STAFF RECOMMENDATION

107 Lindsley Park Drive

April 22, 2020

Application: New Construction—Addition; Setback Determination

SITE PLAN

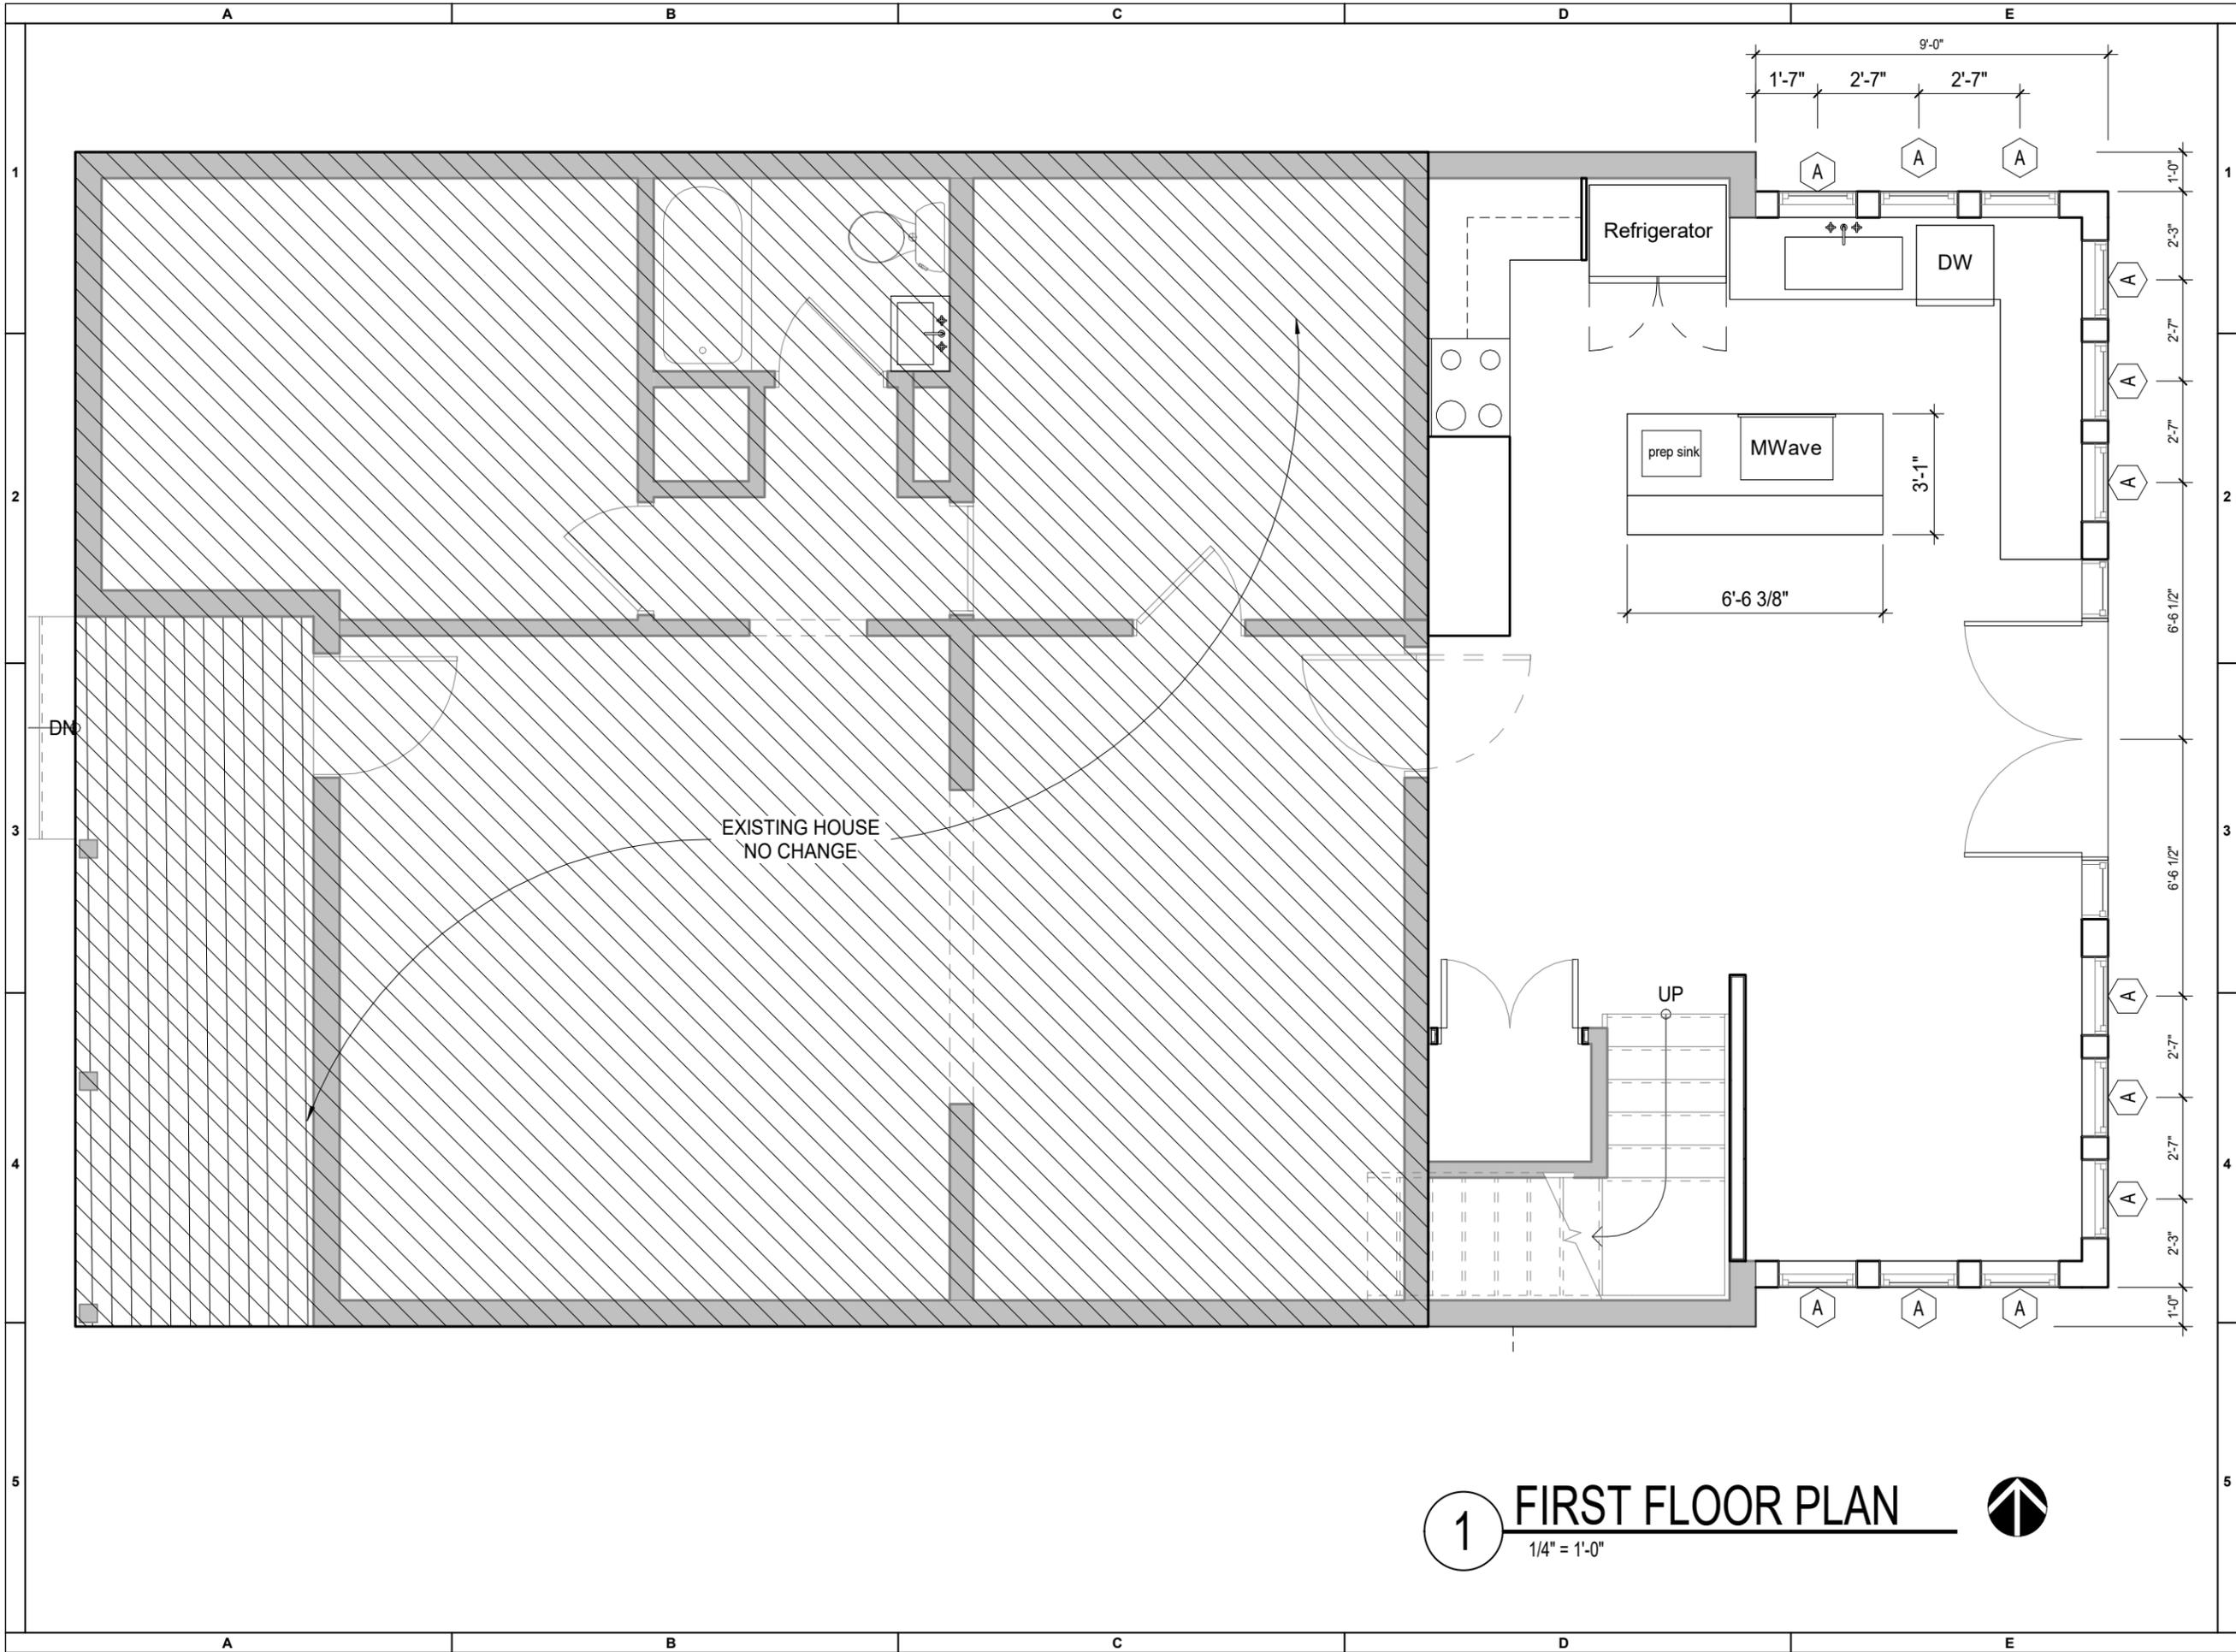
Setback & Rhythm of Spacing: Although the addition steps in from the sides of the existing house and is narrower, the right side of the addition gets closer to the right-side property line because the lot is irregularly shaped, narrowing at the rear. The rear-right corner of the building will be four feet, nine inches (4’) from the property line, whereas the bulk standard requirement is five feet (5’). Because the addition is narrower than the existing house, the addition will not impact the perceived rhythm of spacing between house, therefore staff finds that the setbacks for the proposed addition will meet section II.B.3 of the design guidelines.

Recommendation: Staff recommends approval of the proposed rear addition at 107 Lindsley Park Drive with a four foot (4') right side setback, with conditions that:

EXTERIOR ELEVATIONS

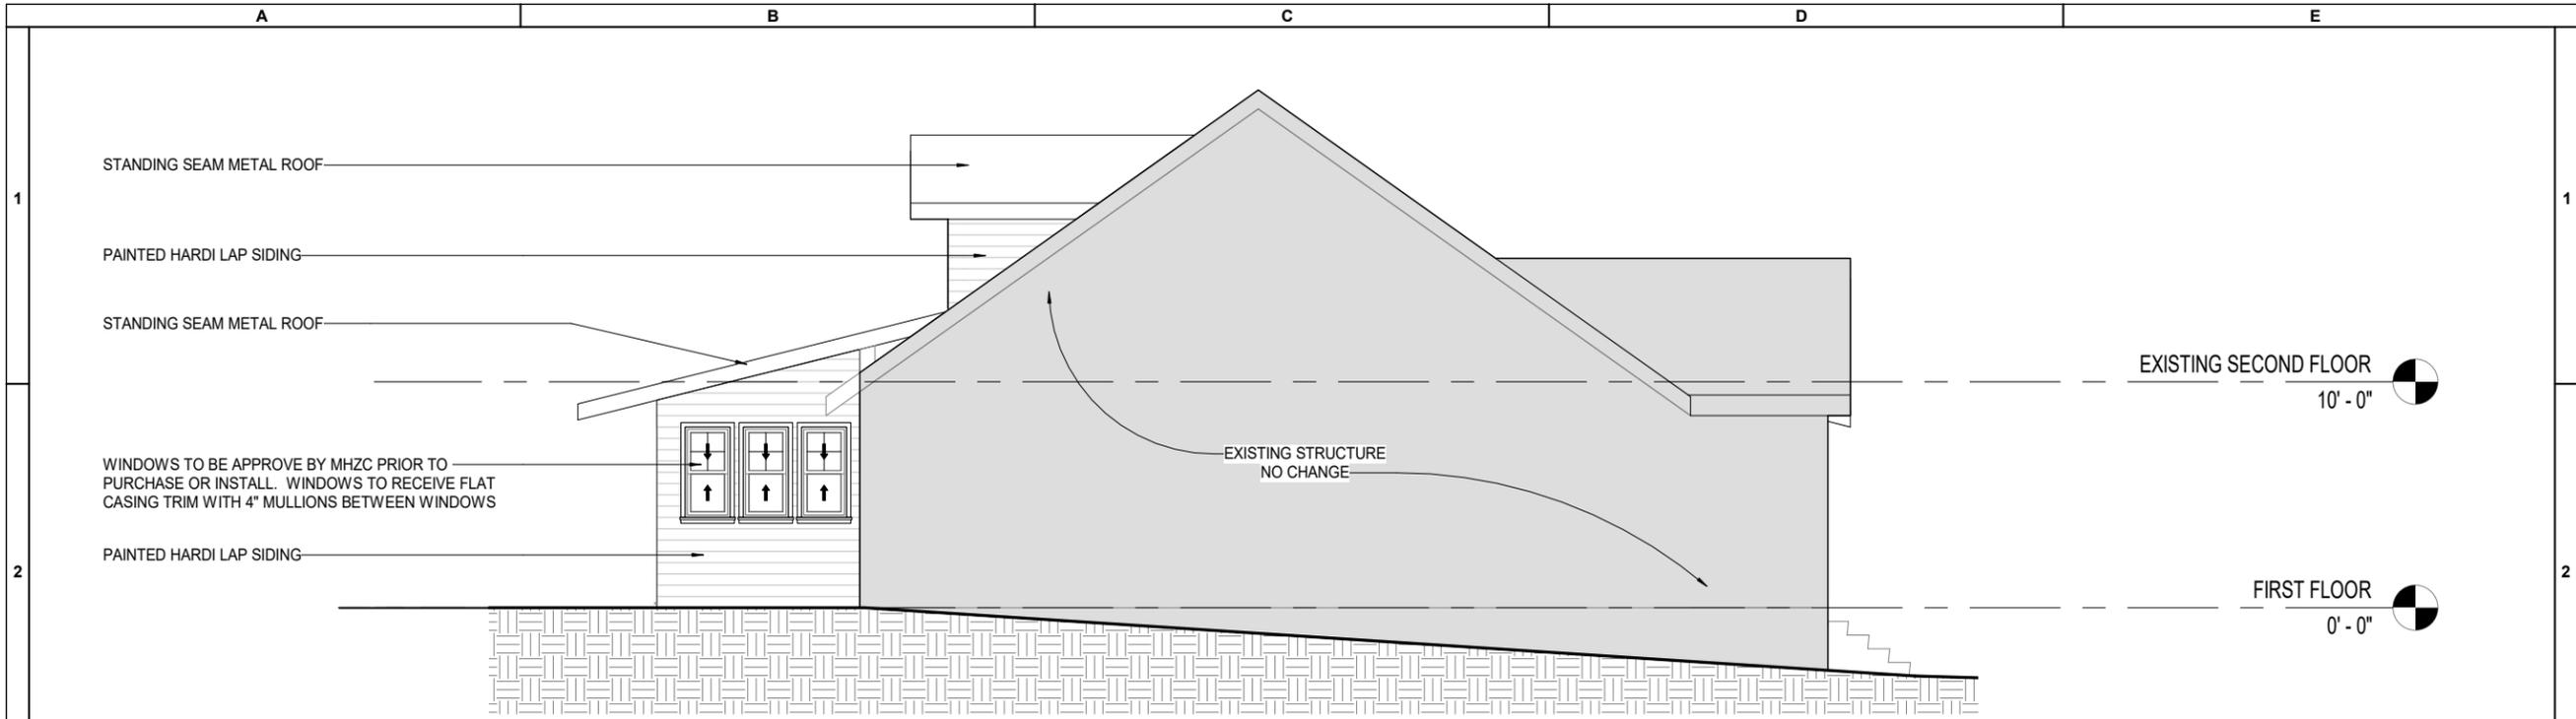
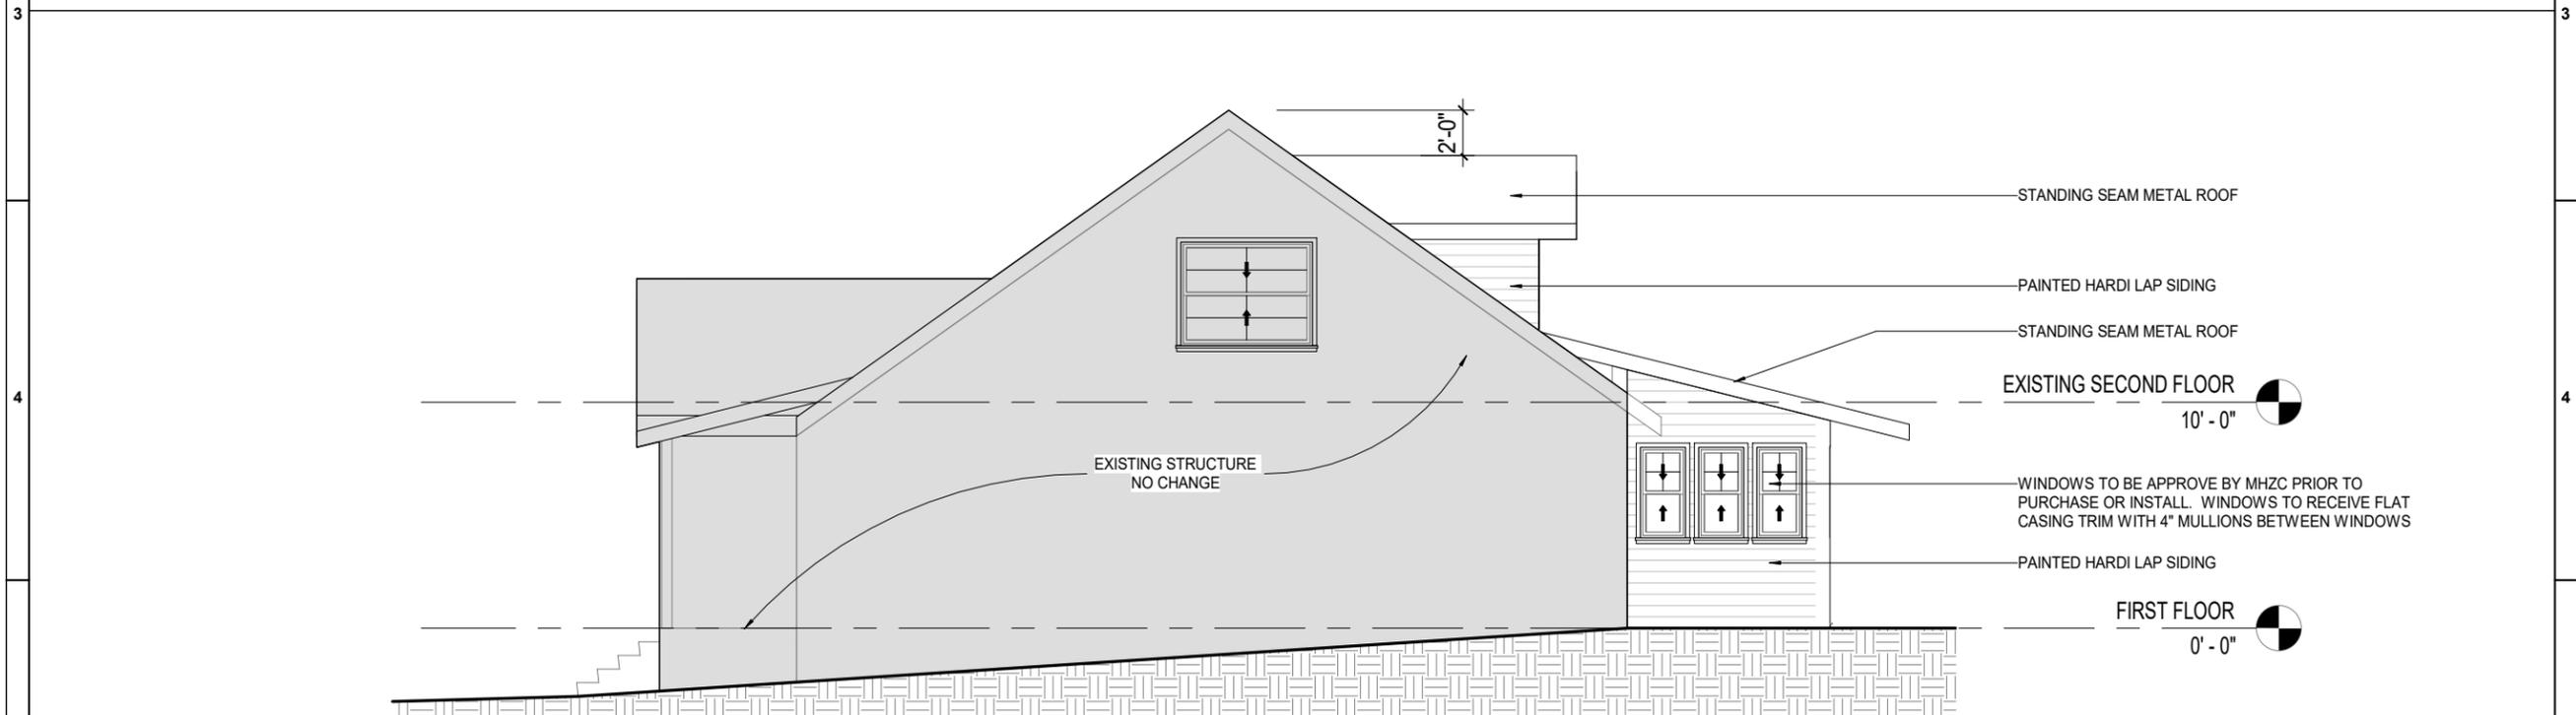
Height & Scale: The first-story addition will be stepped in one foot (1’) from the sides of the house, and will extend nine feet (9’) to the rear. The roof of this component of the addition will tie into the rear of the building, approximately ten feet (10’) below the ridge.

The new rear dormer will be stepped in three feet, eleven inches (3’-11”) from the existing side gable walls, with a rear-facing gable sitting two feet (2’) below the existing roof ridge.

Roof form: The gabled roof of the dormer addition and the shed roof of the first story addition will both have a 3/12 pitch. These pitches are compatible with the historic house and meet section II.B.5 of the design guidelines.

Proportion and Rhythm of Openings: The window openings on the new addition will be vertically oriented, arranged in sets of three on the sides of the first-story addition. These are consistent with the openings on the historic house. Staff finds that the window proportion and rhythm of openings are generally compatible with the historic house and that the project will meet section II.B.7 of the design guidelines.
